**From:** [S Mason](#)  
**To:** [Rebecca Noecker](#)  
**Cc:** [Spencer Miller-Johnson](#); [\\*CI-StPaul Contact-Council](#)  
**Subject:** Public Comment in Opposition to Proposed EGAOD changes. Add a rear setback and step back to the EGAOD.  
**Date:** Friday, July 19, 2024 1:06:09 PM  
**Attachments:** [1- ANNOTATED Parritz public comment presentation.pdf](#)  
[2-ANNOTATED Parritz public comment presentation.pdf](#)  
[3-ANNOTATED Parritz public comment presentation.pdf](#)  
[4-comments.pdf](#)  
[5-Comments.pdf](#)

ANNOTATIONS TO PUBLIC COMMENT IMAGES

695 Grand Ave: Massing as constructed

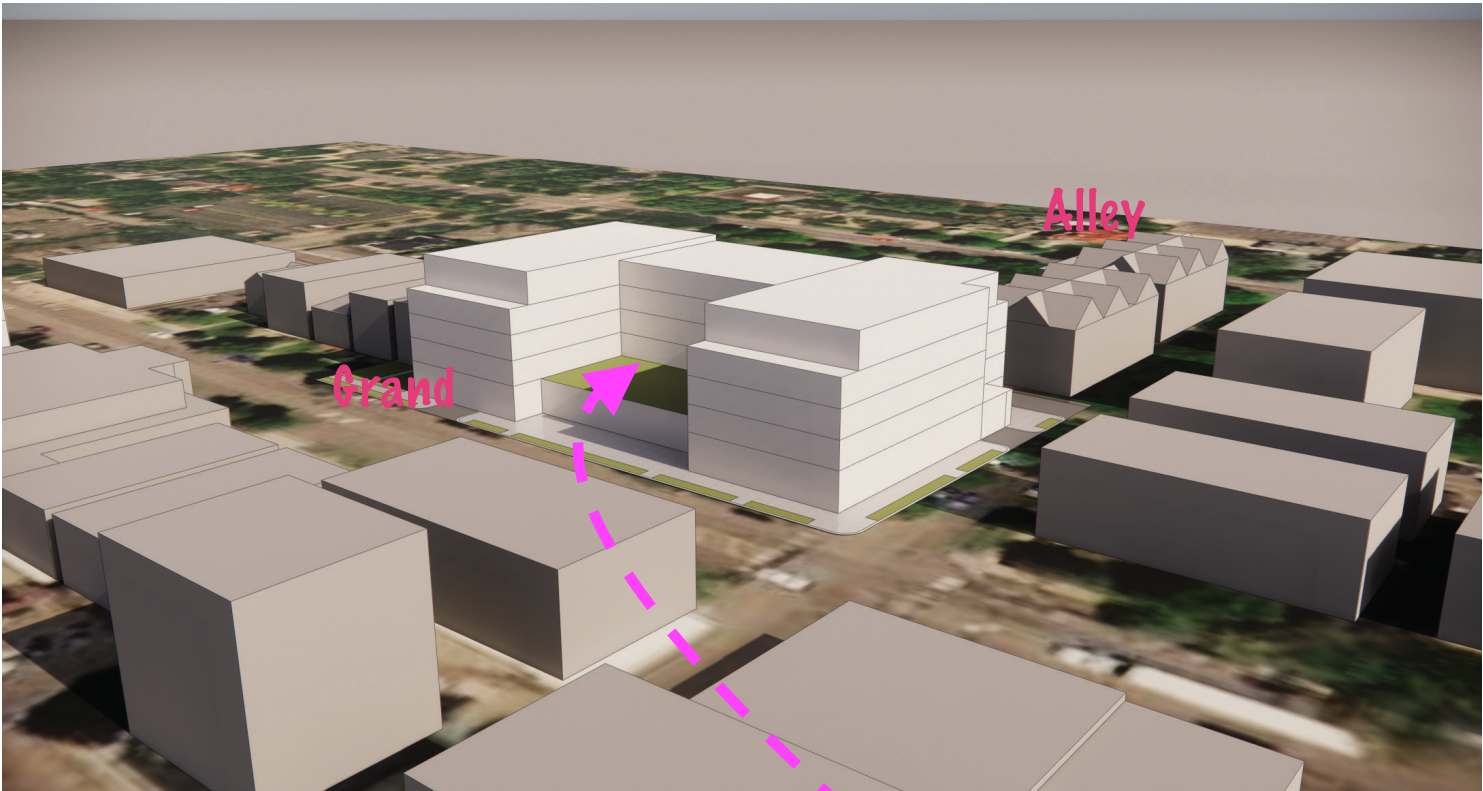
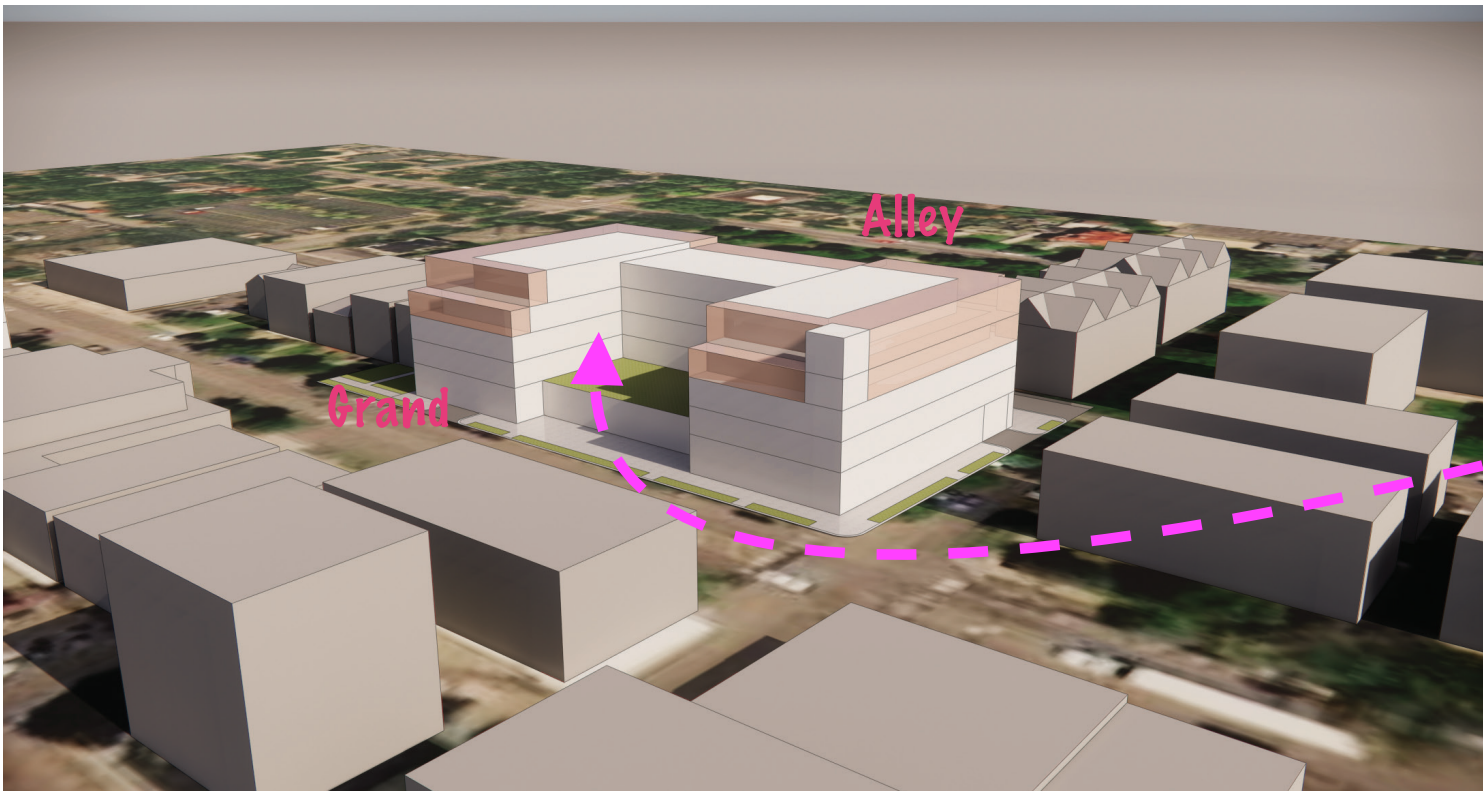
1 Why, in all of these, is there LESS bulk and building mass facing Grand?

And MORE bulk close the neighbors?

Why is there a giant area on Grand that could be built, but wasn't?

The green area in the center is buildable.

Why is it NOT built?

695 Grand Ave: Possible Massing

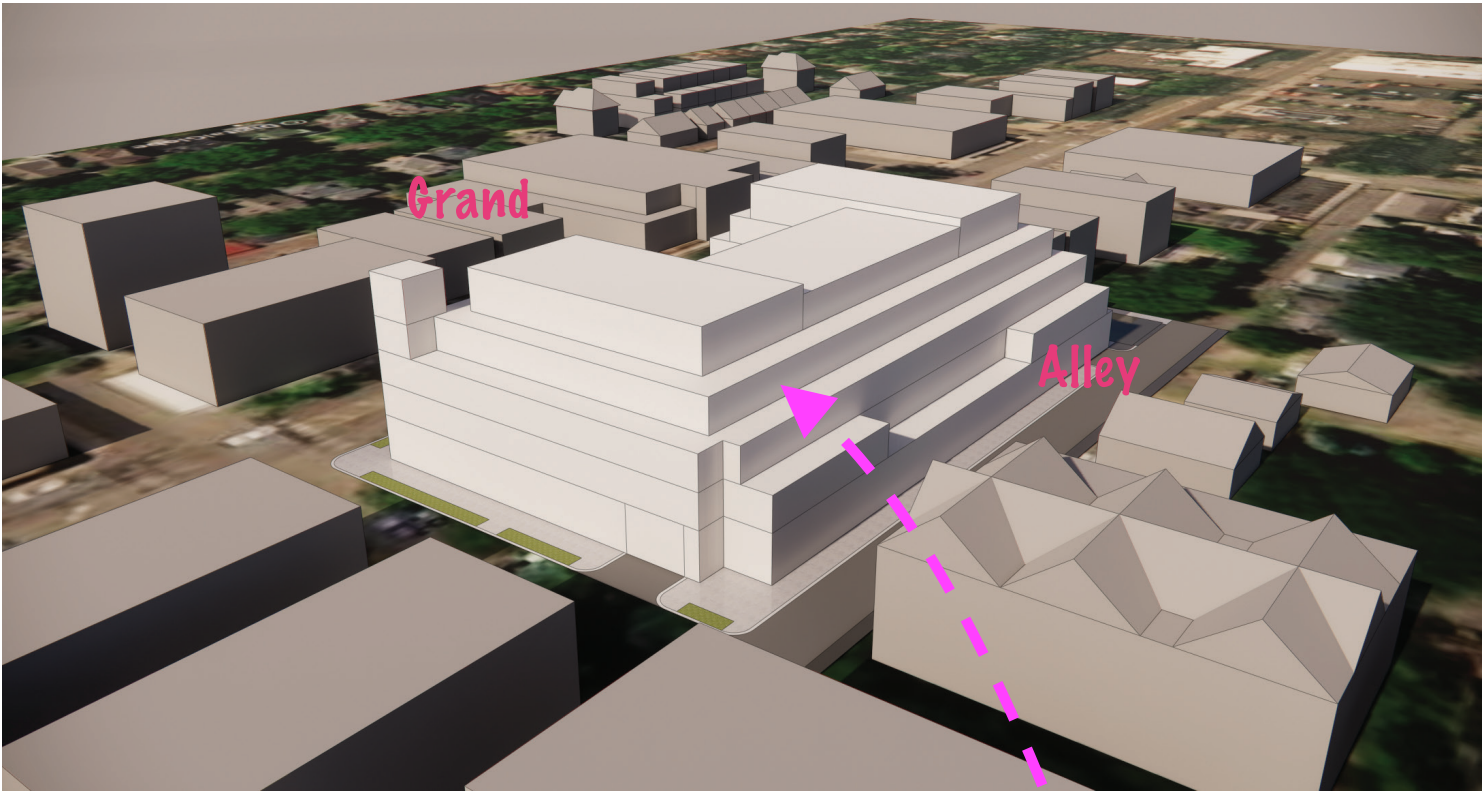
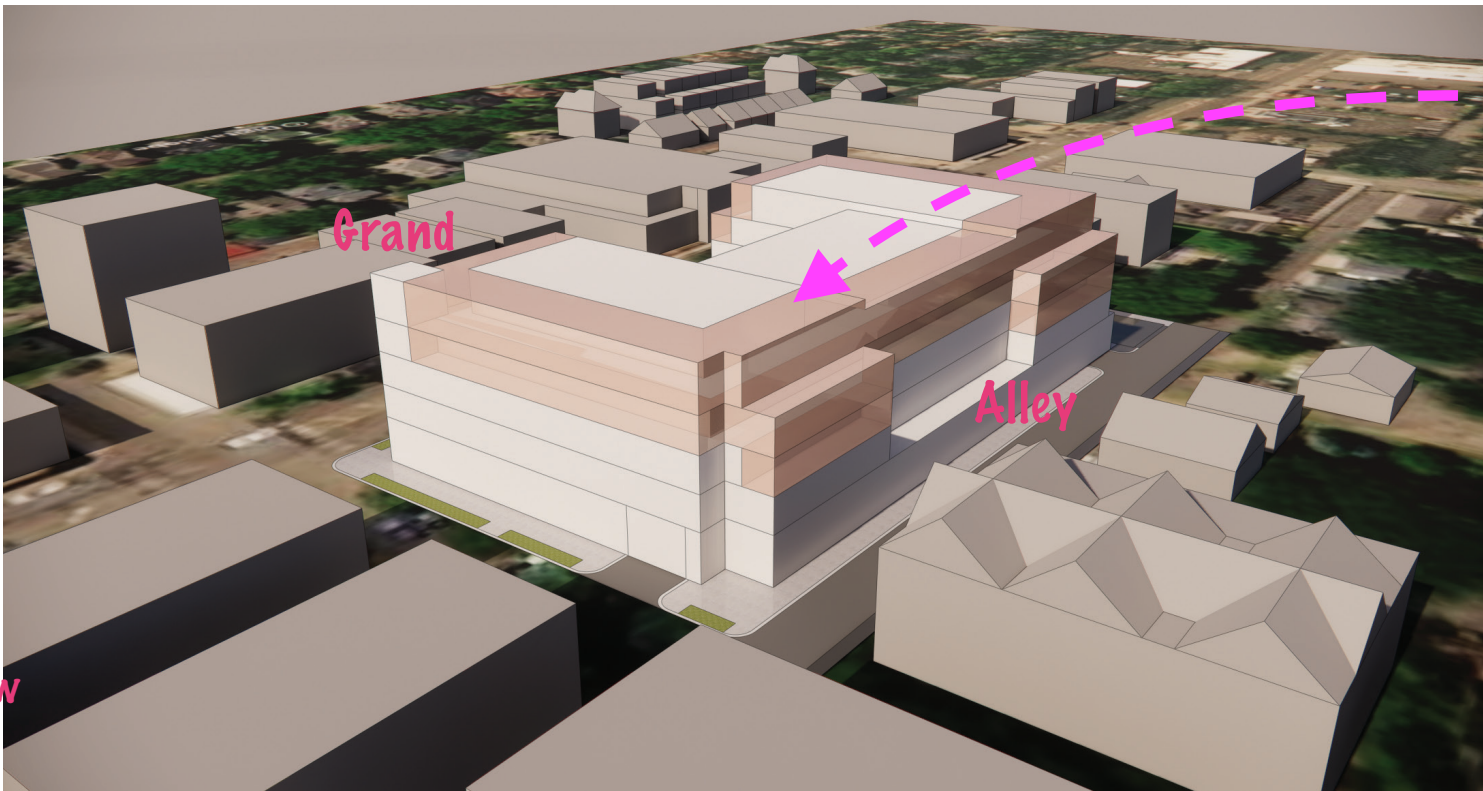
Imagine this flipped.  
Why is there more height  
and more massing  
at the rear,  
toward the residential  
neighborhood?

Residential neighbors near 695 Grand  
have been negatively impacted by the  
tall walls that were constructed:

- \* ice build up in the 6-month fully shadowed alley has impeded access & trash collection
- \* a 90 dBA piece of equipment installed in the narrow strip of land along hte alley runs 24-7 in the summer, limiting neighbors ability to use outdoor spaces and have open windows.
- \* Litter (chiefly cigarette butts & dog poop) is a huge problem as the building has no outdoor space for employee smoking or dog relief.

This would be somewhat better.

Removing the highlighted  
areas would be an improvement  
for residential neighbors to the north.  
However, there is still too much  
building oriented toward low density.

Why is the building oriented  
away from Grand?

Since Grand needs development, then the building and its bulk, as well as its noise, deliveries and activity should all be oriented toward Grand

734 Grand Ave: Possible Massing

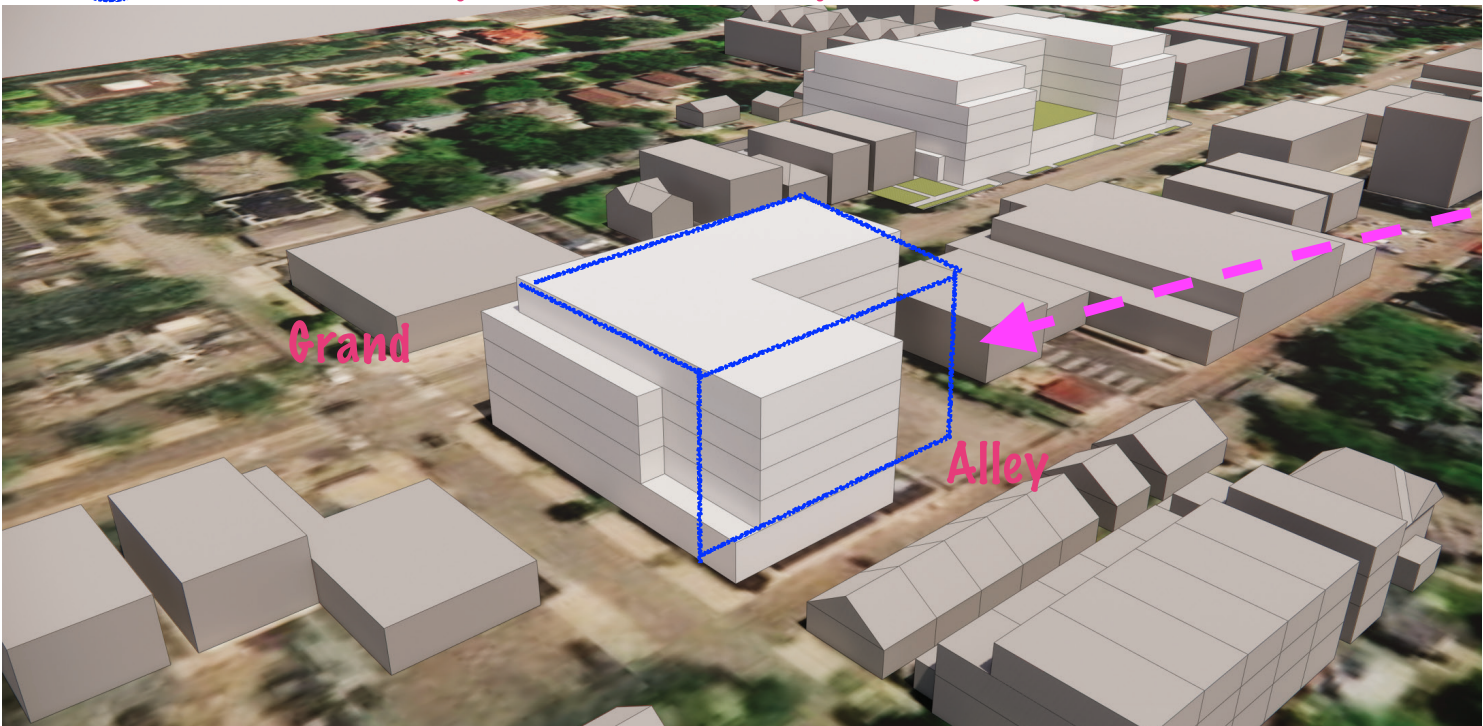
These "POSSIBLE MASSINGS" are better than what was built at 695 Grand.  
The lower images show better "transitions" to sensitive areas, to the housing & neighbors NOT on Grand

But why does the Tall Height and Large Bulk need to come all the way back to the alley?  
Why not provide a buffer space to protect the residents on Lincoln from the noise, loss of privacy, etc.

This is the Walgreens sight. They currently have a tall fence to protect the neighbors from noise etc. Parking comes from Grand. Deliveries happen from Grand & Grotto. The alley is a quiet buffer, This design puts all the noise, traffic and delivery pressure on the residential alley. There is no place for moving trucks and deliveries for the (presumed) 80+ luxury apartments. This layout would likely have noisy equipment installed right at the alley, close to neighbors. This design reduces privacy & provides no buffer.

The Overlay must provide protections for the neighbors on Lincoln, Summit, & side streets.

An alley setback + stepback would protect residential neighbors & still allow more than ample building volume

Here is an image of 695 Grand flipped, with December Shadows.

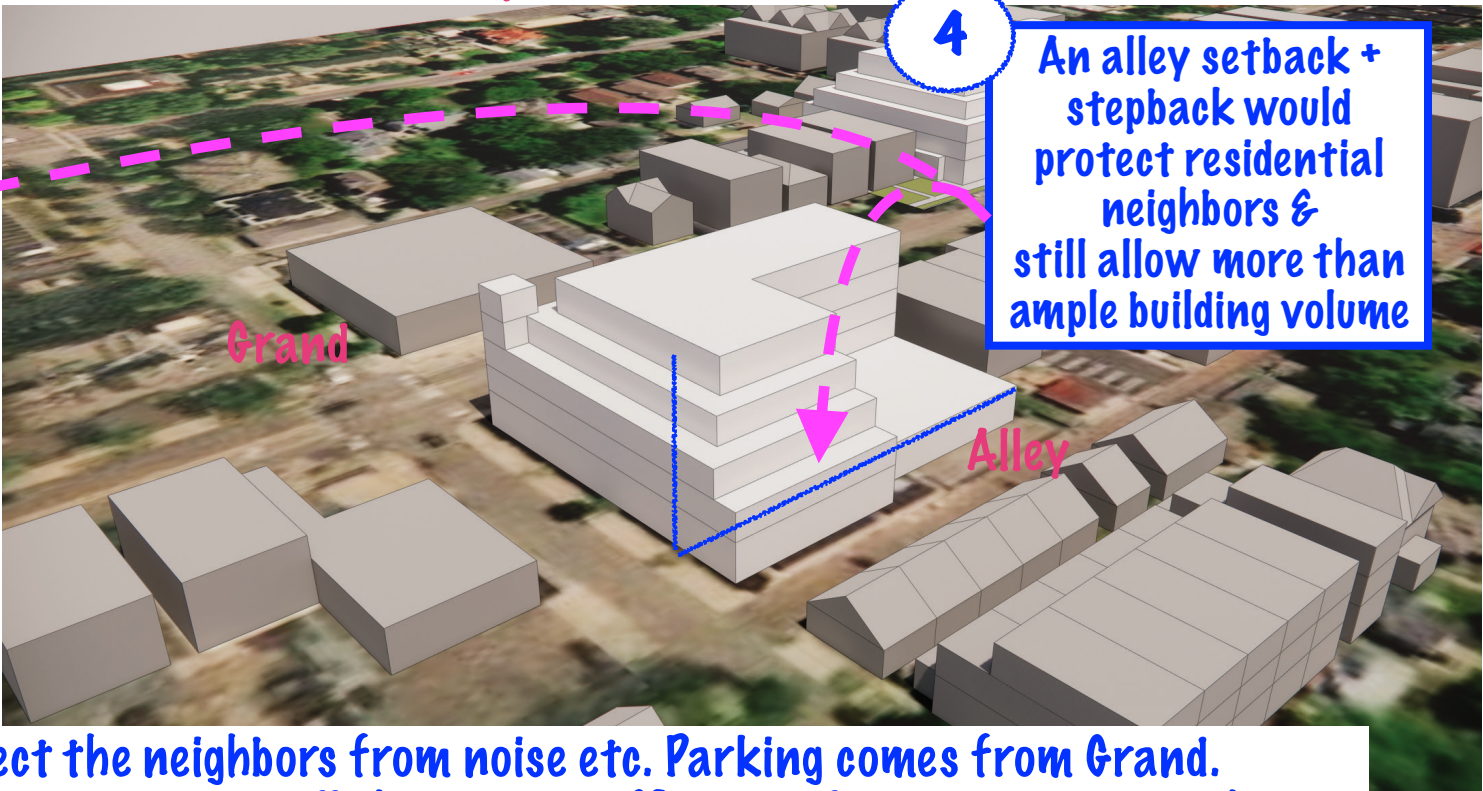
This simple move puts the height and massing toward Grand, mitigating negative affects on the residential neighborhood.

Why doesn't the EGAOD require this?

Notice that the yards and roofs of all the residential houses, carriage houses and garages get ice-melting sun.

They can install solar panels
